Application is hereby made for revising the plan(s) for: Preliminary/Final Land Development Plans for JPMorgan Chase Bank

RE: Preliminary/Final Land Development Plan Review
JPMorgan Chase Bank, N.A.
1729 Street Road
TMP # 02-043-305
Bensalem Township, Bucks County, PA
Project No. BENS R 1280

We are in receipt of the JPMorgan Chase Bank, N.A. Preliminary/Final Land Development Plan Review Letter dated July 14, 2021. Please find enclosed responses to the previously mentioned documents.

SHEET NO.
C19.2
SHEET 21 OF 23

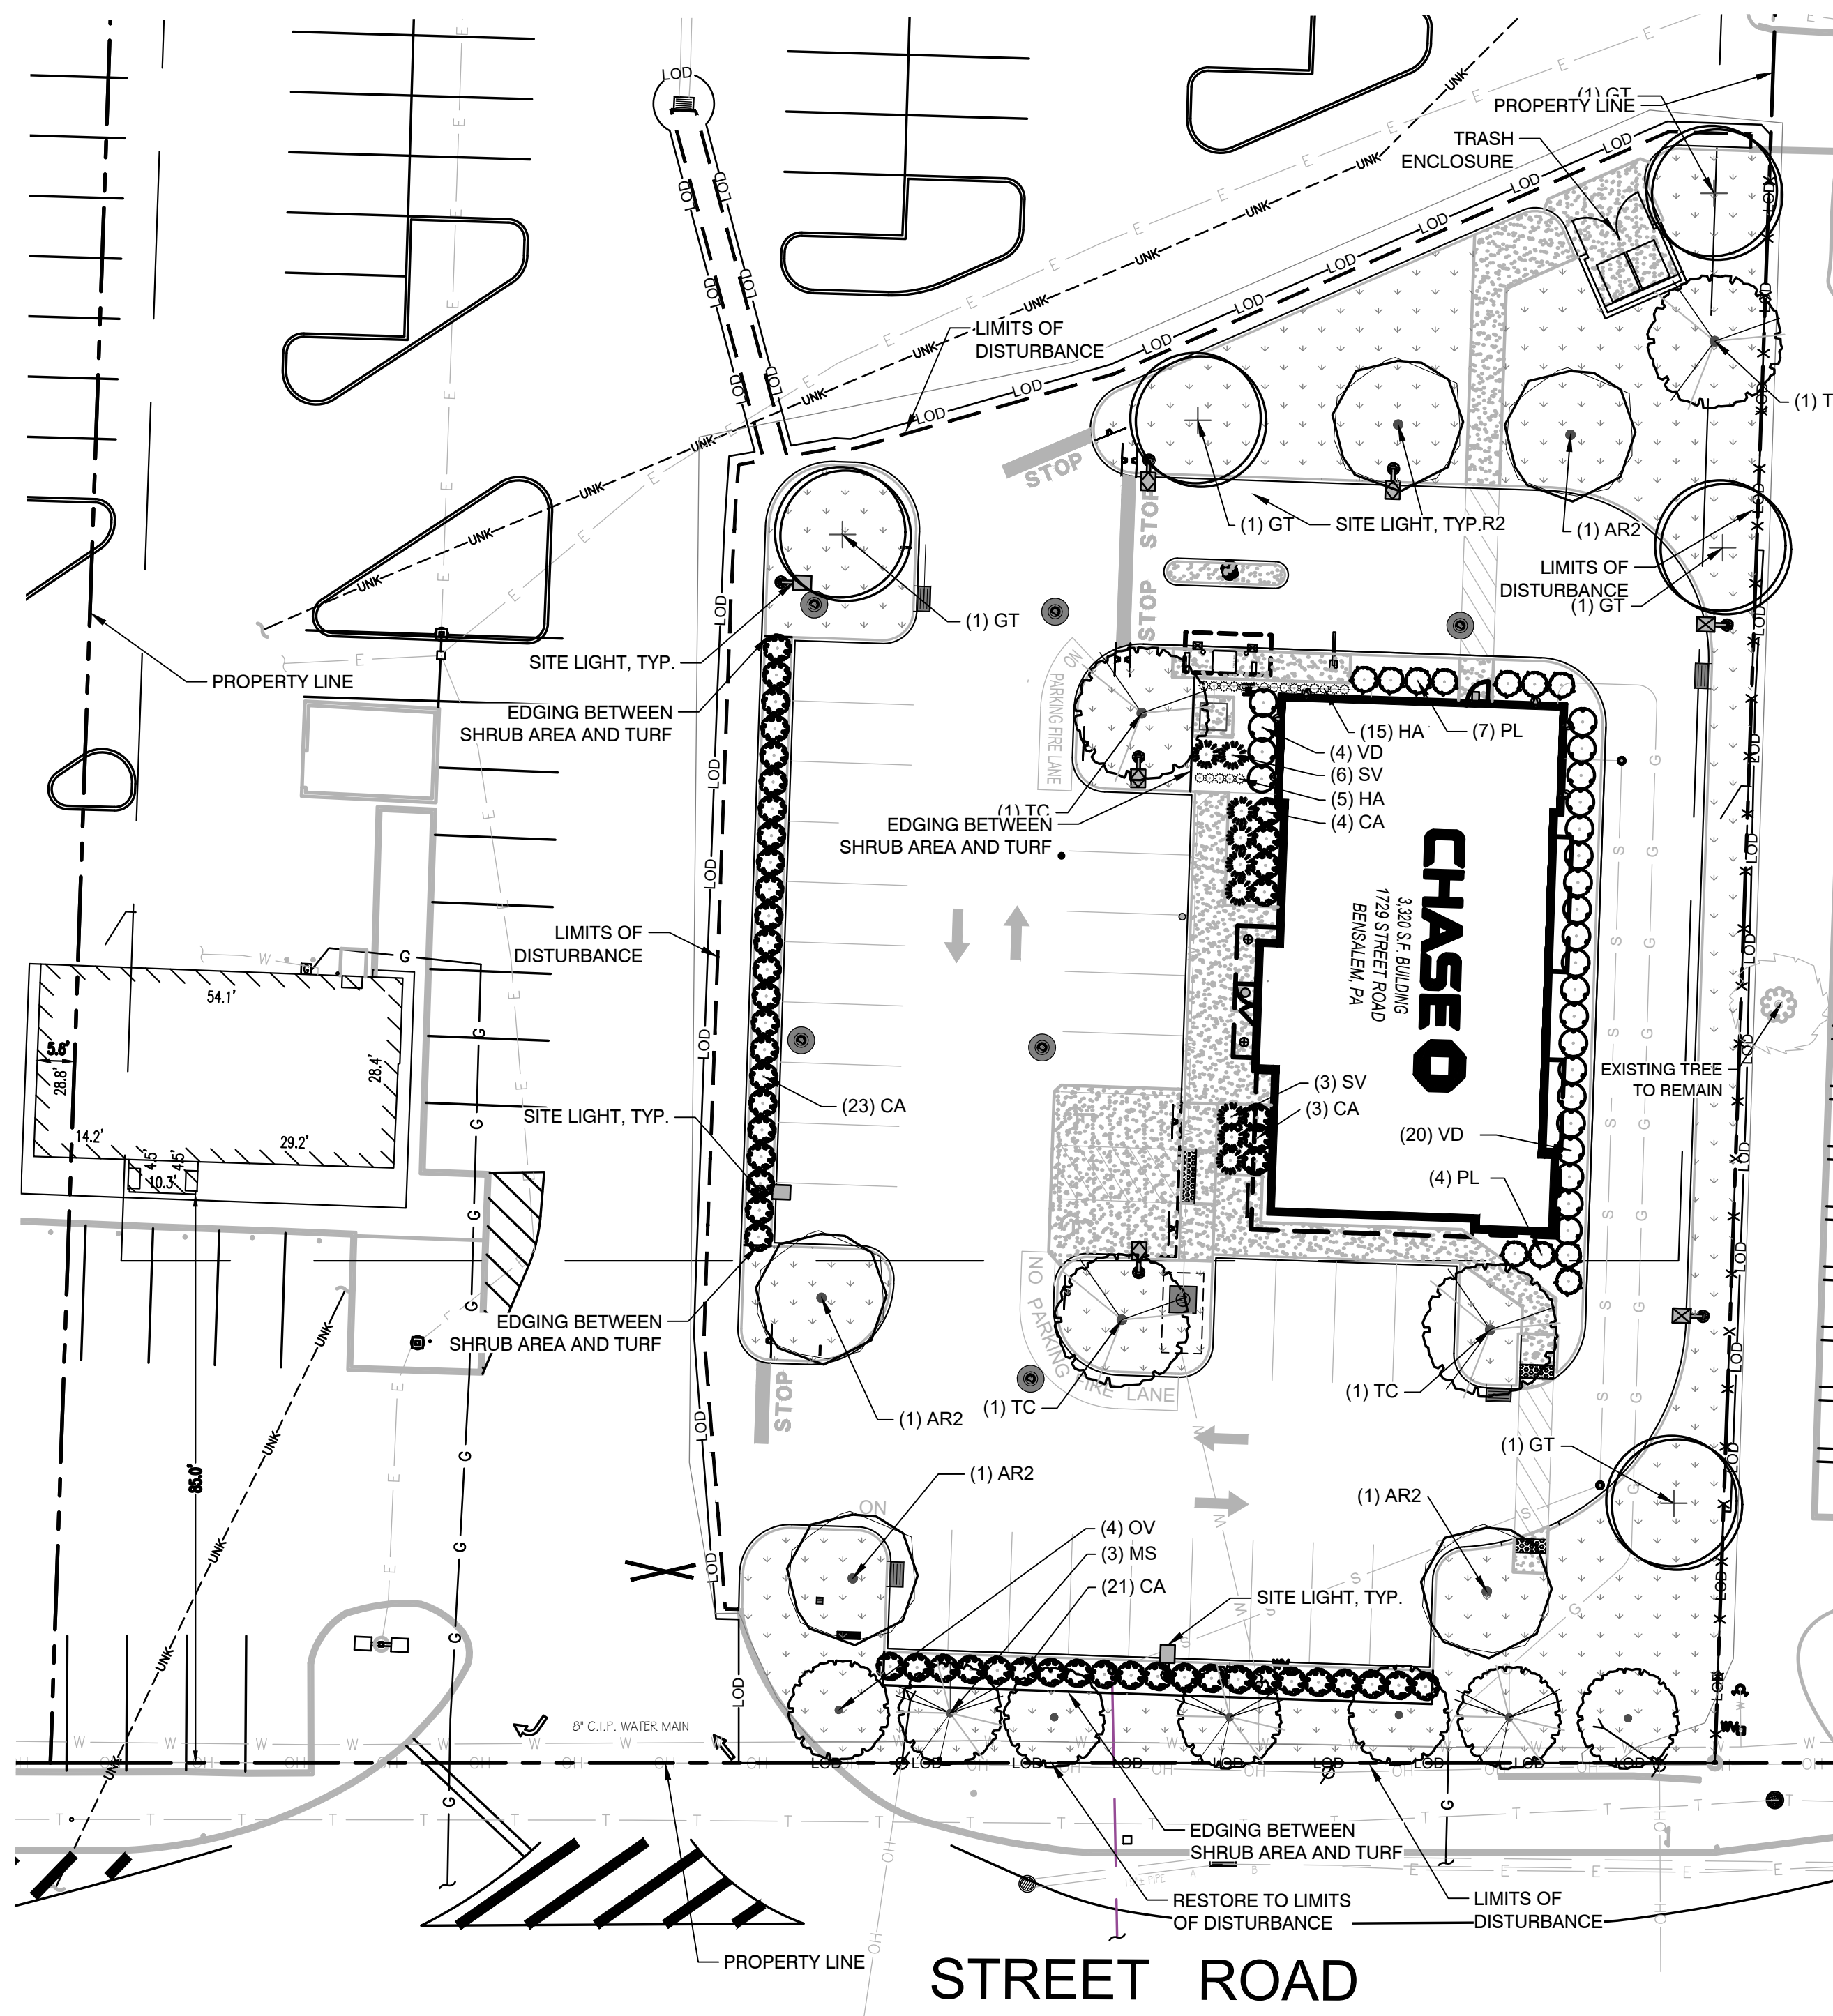
- Provide trash truck turning templates.
- Response 5** **Completed. Please see the Emergency Access Plan – B – Sheet C19.2 (Sheet 21 of 23).**
- Comment 6** In accordance with ZO Section 232-713(a), a permit shall be obtained from the Township before erecting, placing, rebuilding, significantly altering, reconstructing or moving any sign...

- Response 5** **Completed. Please see Construction Details – Sheet C17 (Sheet 18 of 23).**
- Comment 6** Provide a truck turn showing a garbage truck accessing the dumpster area.

- Response 6** **Completed. Please see the Emergency Access Plan – B – Sheet C19.2 (Sheet 21 of 23).**
- Comment 7** Coordinate work between the shopping center redevelopment and this site (drainage, traffic control, drive aisle changes). Provide notes on the plans and correspondence regarding these items. Provide site traffic control for trenching operations if necessary.
